TECHNICAL NOTE 1

DATE:	14 December 2023	CONFIDENTIALITY:	Confidential
SUBJECT:	Response to Active Travel England Comments		
PROJECT:	70094210 - Land at Buntingford West	AUTHOR:	Gideon G
CHECKED:	Mehmet A	APPROVED:	Mehmet A

This Technical Note (TN) has been prepared by WSP on behalf of Vistry Homes in response to Active Travel England (ATE) comments raised regarding the Buntingford West application (ref 3/23/1447/OUT), ATE ref ATE/23/00368/OUT on 07 November 2023.

TITLE: **LUYNES RISE ACTIVE TRAVEL SCHEME DESIGN**

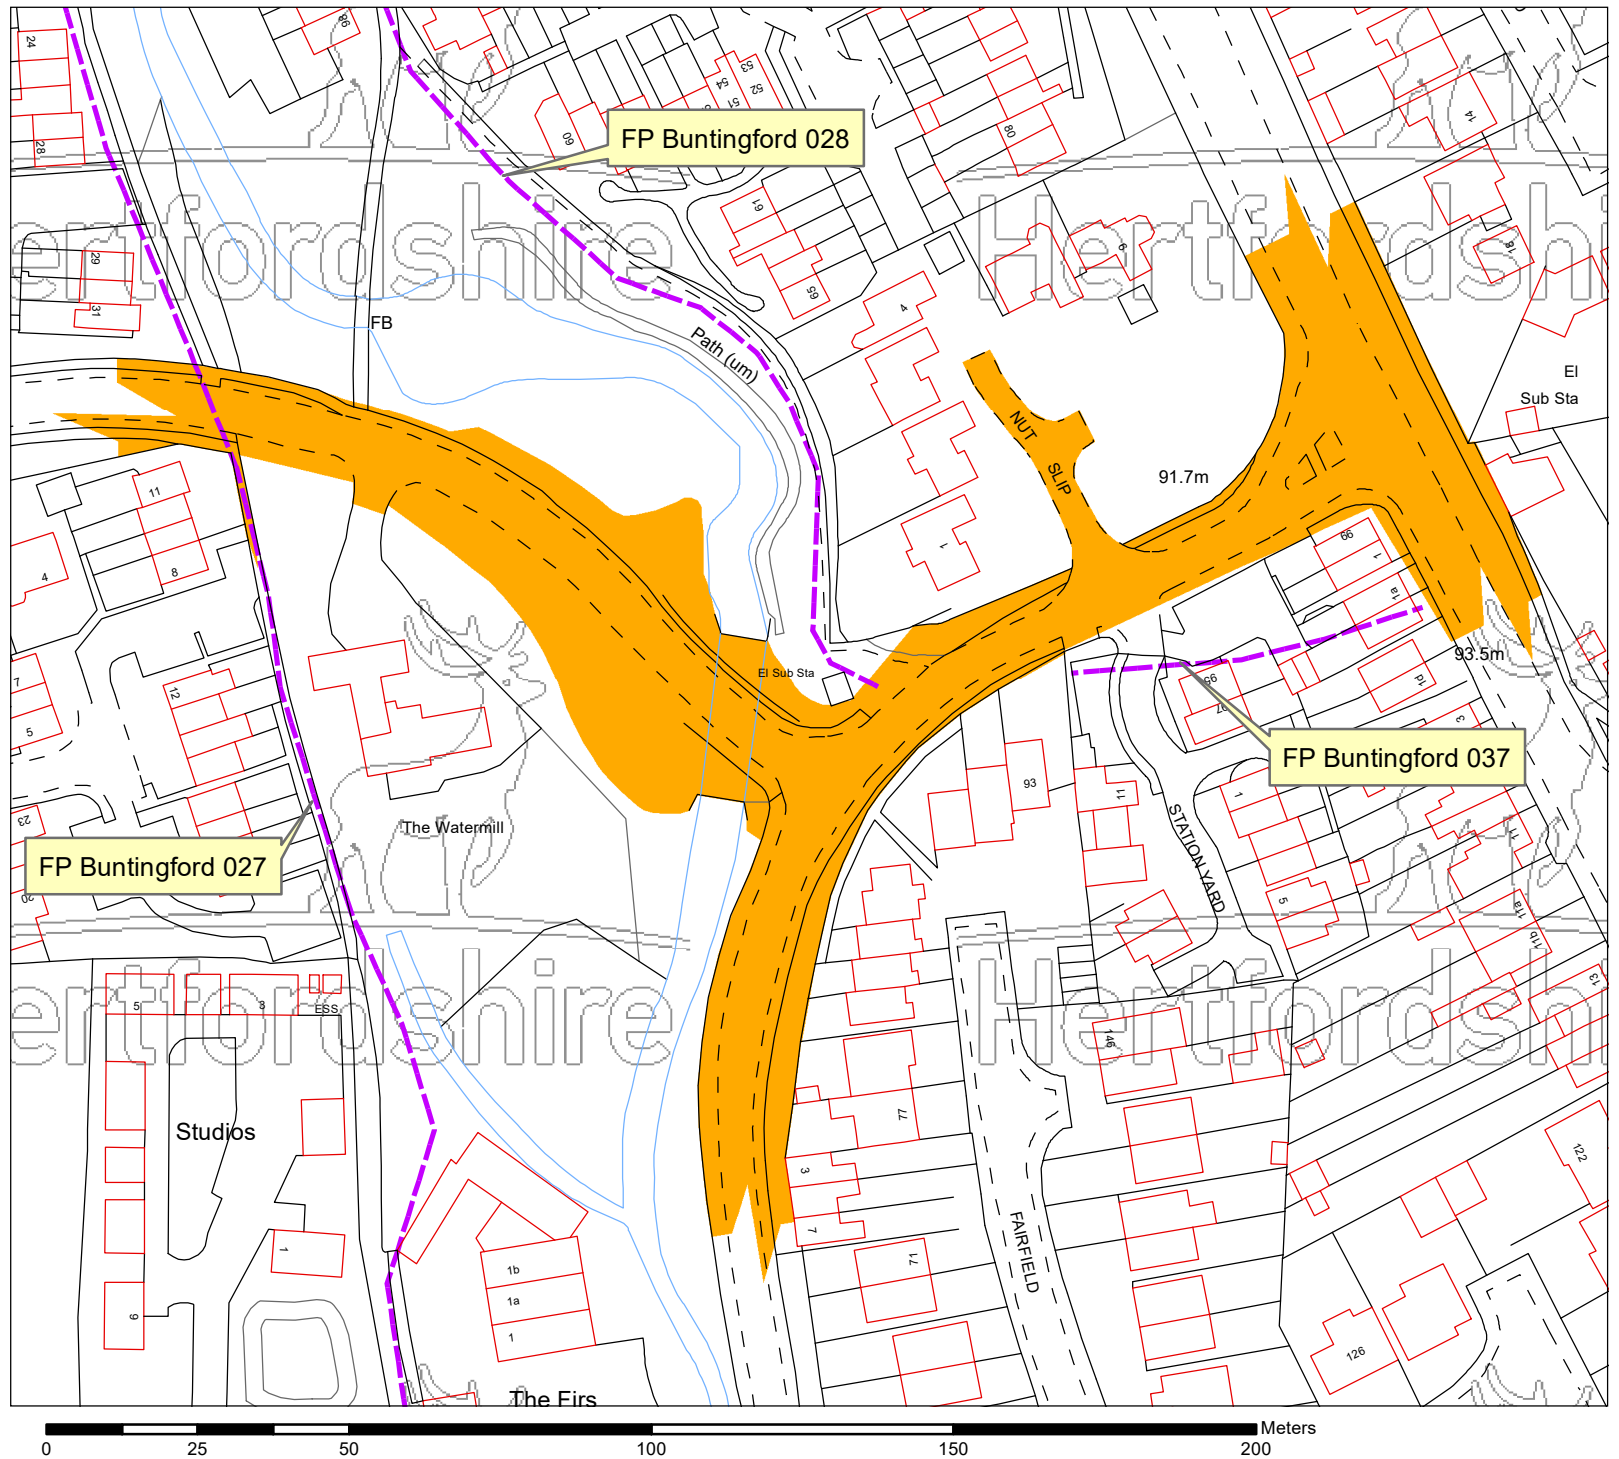
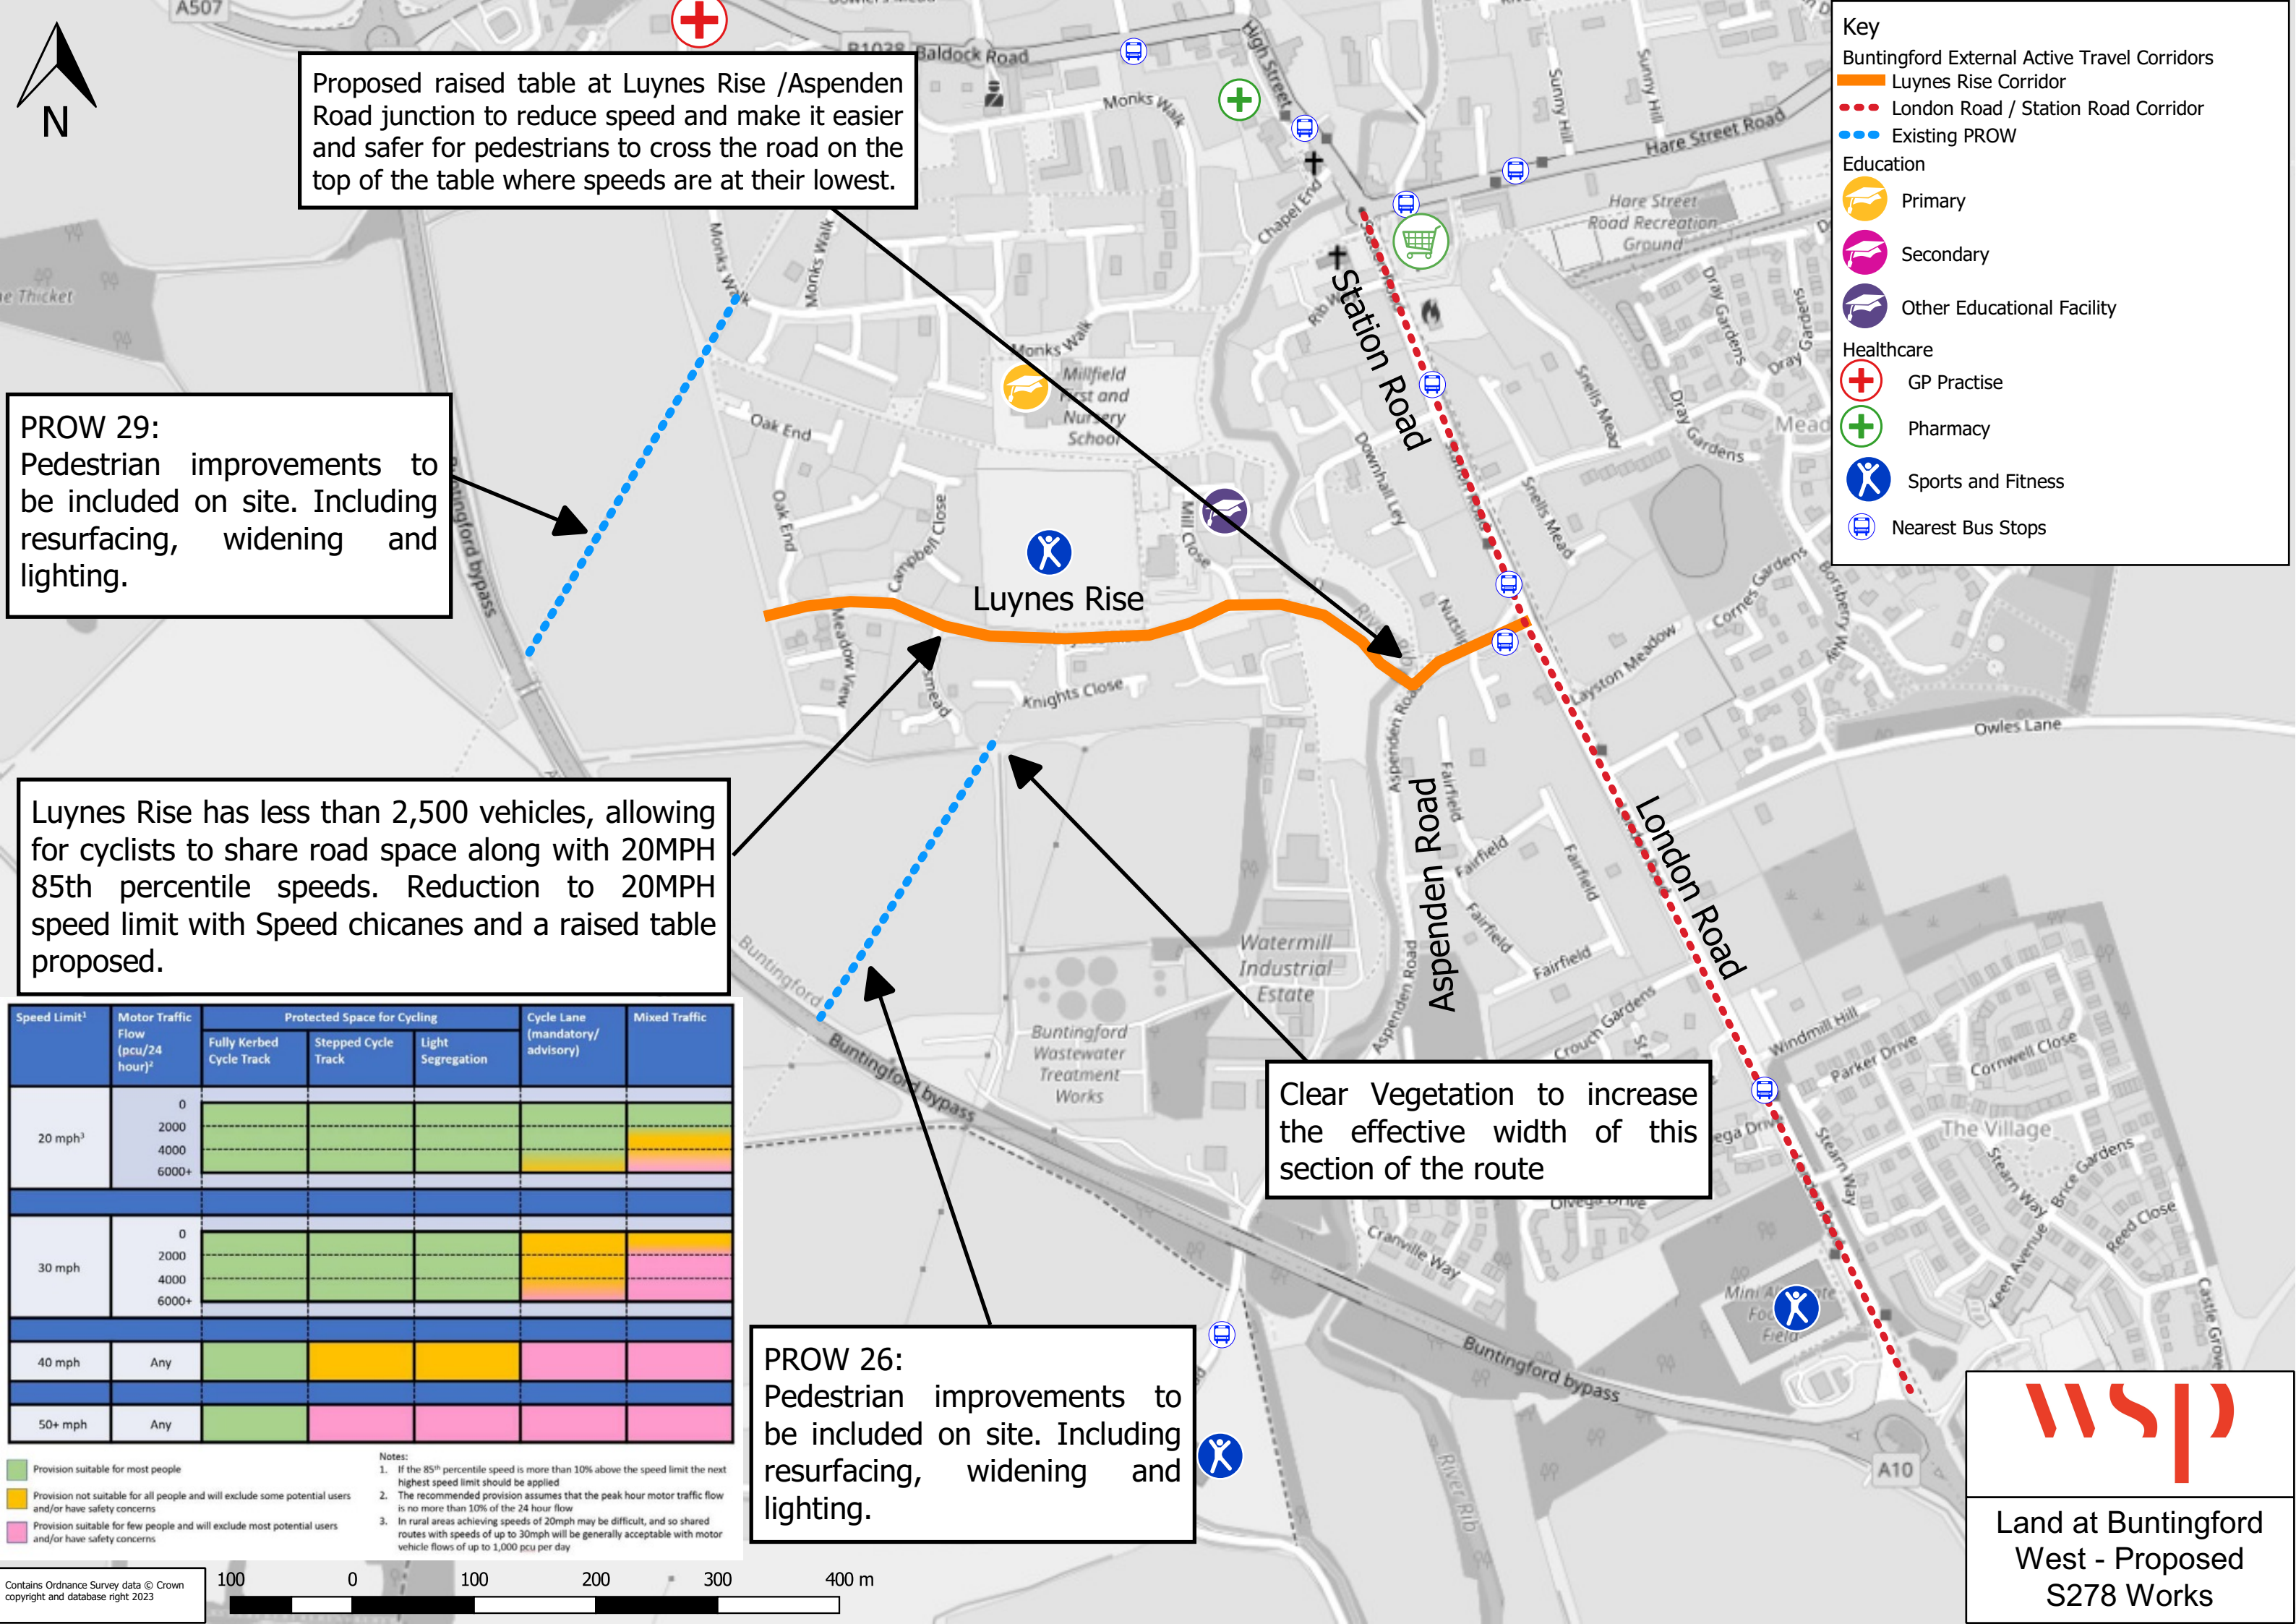
This is the primary connection to the site for walking, wheeling and cycling and provides a link to the improved cycle network on Station Road and on to the High Street. A design for this access is required, and clarity is sought as to whether it is intended as a bus link as well as an active travel link.

The response states that the traffic flows on Luynes Rise and Aspenden Road are less than 2500 vehicles per day, the survey data relating to traffic flows and speeds could not be located in the TA, however given that speed limit is 30mph on these roads, Figure 4.1 of LTN1/20 indicates that provision will not be suitable for all people and that light segregation is recommended. As these are residential roads lowering the speed limit to 20mph, with effective traffic calming, is an option that should be discussed with the highway authority. There are also stretches of the route that do not have footways or the footways are less than 2m in width.

The two strands of S106 are noted, however ATE would want to see improvements on this route between the site access and Station Road provided by the developer as S278 works, this will ensure that that works are delivered in accordance with the time scale of the construction and occupation of the site. Outline plans for a scheme should be provided at this stage to ensure deliverability, the scheme should be developed in consultation with the highway authority and safety audits provided as necessary.

Following a meeting with HCC on the 30th of November 2023, it was agreed that speed reduction measures be implemented on Luynes Rise to facilitate safe active travel connection to the ATF route on Station Road/London Road. [Query – is this the primary connection for walking to the High Street? I consider Footpath Buntingford 041 (past Millfield School) and Footpath Buntingford 029 (past Monks Walk) are more direct. Do we query this and refer to Luynes Rise as primary cycle route but a secondary walking route?]

Details of the design were discussed with HCC including chicanes with cycle bypass and footway widening where possible. A draft design has been submitted for HCC's consideration and also attached at Annex B.

Proposed raised table at Luynes Rise /Aspenden Road junction to reduce speed and make it easier and safer for pedestrians to cross the road on the top of the table where speeds are at their lowest.

Luynes Rise has less than 2,500 vehicles, allowing for cyclists to share road space along with 20MPH 85th percentile speeds. Reduction to 20MPH speed limit with Speed chicanes and a raised table proposed.

Land at Buntingford West - Proposed S106 Works

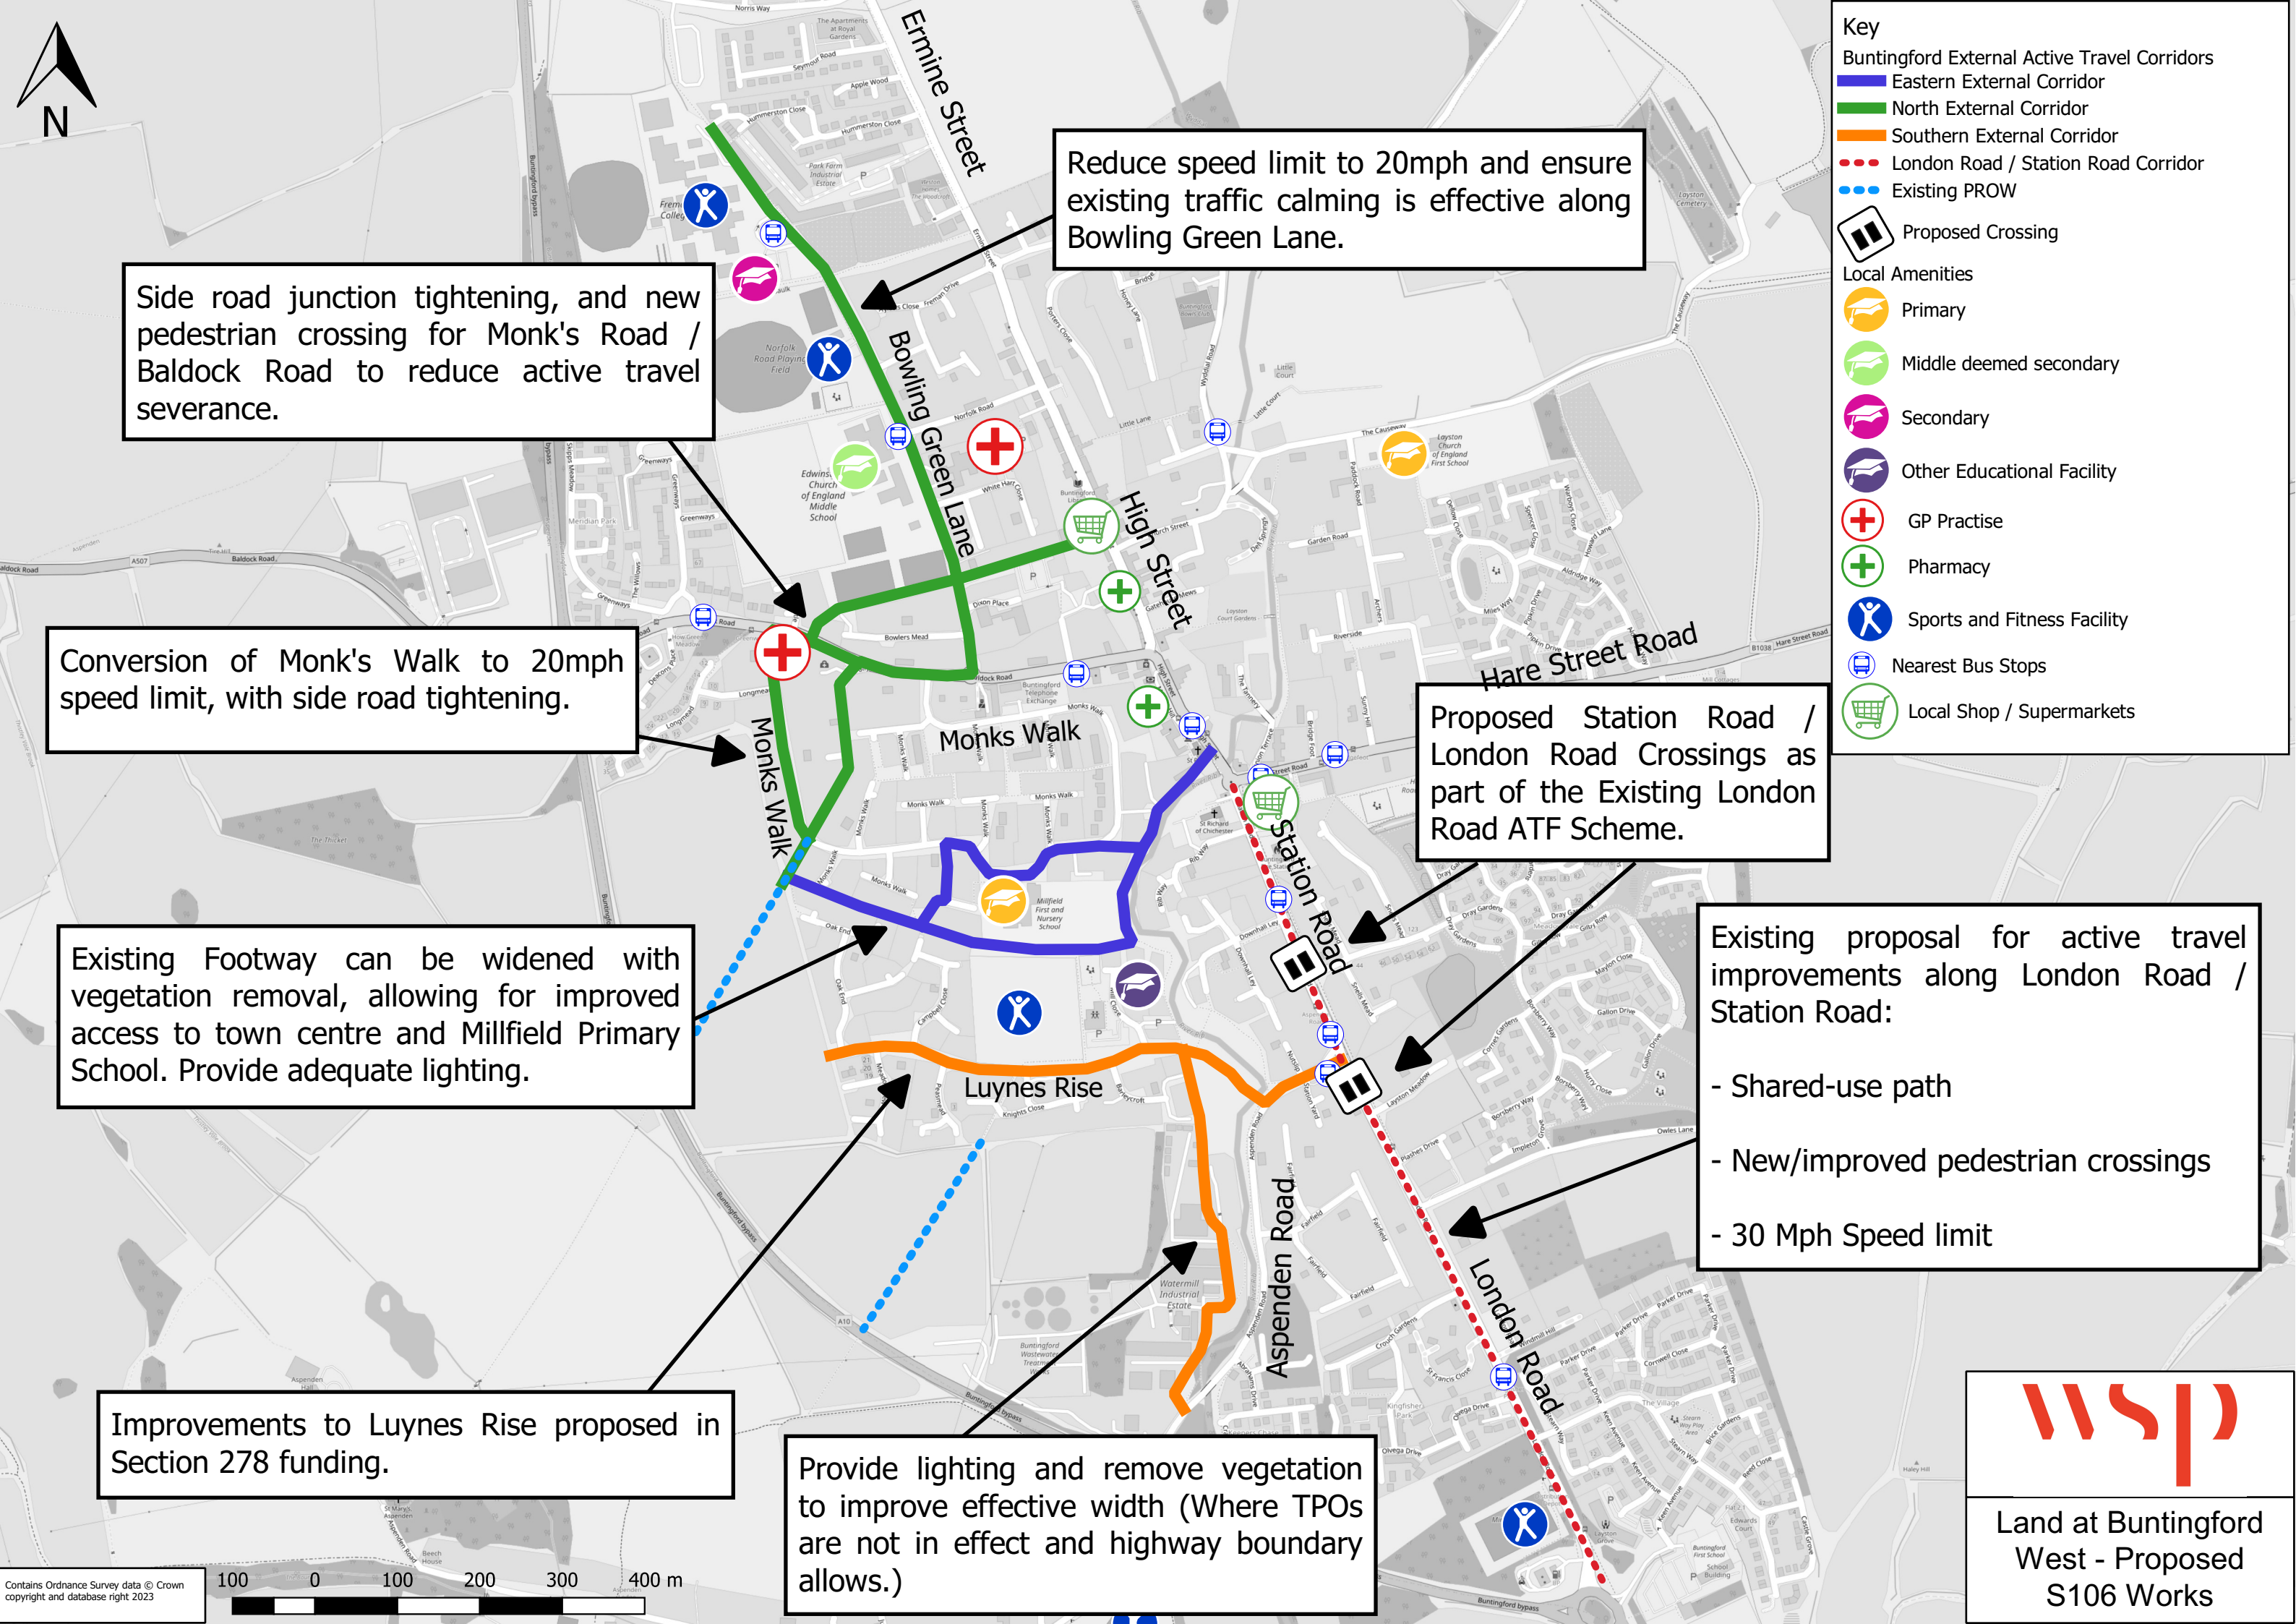
The use of the Level of Service Tool and Walking Route Audit Tool and provisions of plans with photographs on are welcome. It is noted that the scores for the route are generally low. In some cases this is because of physical constraints that cannot be changed (alleyways between houses) but there are other issues that can be addressed such as surfacing, lighting, dropped kerbs, signing and crossings. The next step is to use the audit to develop a suite of measures to improve the routes and help embed cycling not only with the development but connections from the site. Schemes should be developed for key routes with the intention of them being delivered through the S278 mechanism by the developer.

The scope of off-site and on-site works was agreed with HCC at the November 2023 meeting. Maps showing a suite of measures are included at Annex C.

Active travel improvement works further afield will be delivered via S106 as this will not be directly related to the Proposed Development but provides wider benefits to the area. A revised Strand 2 contribution will be calculated if the applicant commits to any off-site works that provides a wider benefit.

Reduce speed limit to 20mph and ensure existing traffic calming is effective along Bowling Green Lane.

Side road junction tightening, and new pedestrian crossing for Monk's Road / Baldock Road to reduce active travel severance.

Conversion of Monk's Walk to 20mph speed limit, with side road tightening.

Existing Footway can be widened with vegetation removal, allowing for improved access to town centre and Millfield Primary School. Provide adequate lighting.
